Product Change Notification / CENO-11FRYW234

CCB 5131 Initial Notice: Qualification of C194 as an additional lead frame material for selected DSPIC33EPxxxxxx, PIC24EP12xxxxxx, PIC24EP25xxxxxx, PIC24EP32xxxxx and PIC24EP64xxxxx device families available in 48L UQFN (6x6x0.5mm) package.

PCN #: CENO-11FRYW234

LEAD FRAME COMPARISON

Pre Change

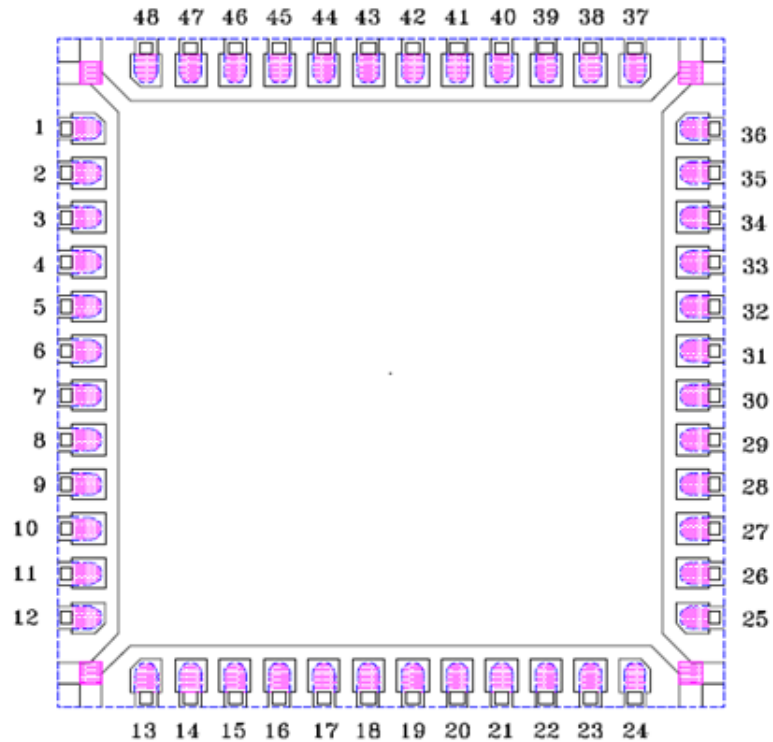
Lead frame Material

EFTEC64T

Post Change

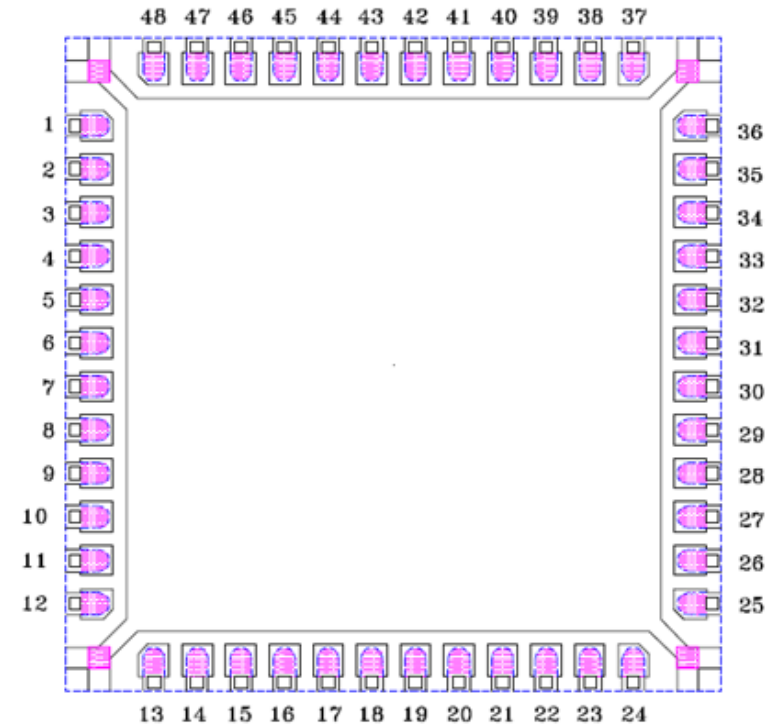
Lead frame Material

C194
